Project No. R2013-03046-(4) - Conditional Use Permit No. 201400029 - RPC Meeting: May 11, 2016 - Agenda Item: 6

Past President Kingdon Chew RE: Comments on Case Number R2013-03046-(4) 18002 Colima Road Project Initial Study (I/S), Mitigated Negative Declaration (MND) and Traffic Impact Study (TIS)

Vicinity Map View and Elevation View of Existing Nursery Across the Street

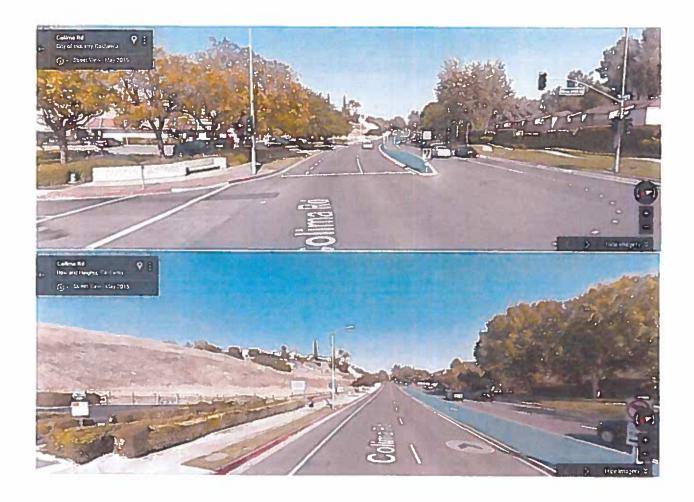
RHCCC further contends that the project is not consistent with the surrounding uses and visual character of the area. The current site, while operating as a commercial plant nursery, is a low impact use and provides a visual character more on the lines of a park than a "commercial" operation. The neighboring adjacent uses are 100% residential (single family and multi-family) and as such the development of a two-story 45' high office building is not consistent with the surrounding area. The touted commercial corridor is located in a neighboring city, are single story units with significant setbacks. See Appendix A: images 1 - 5 for reference.
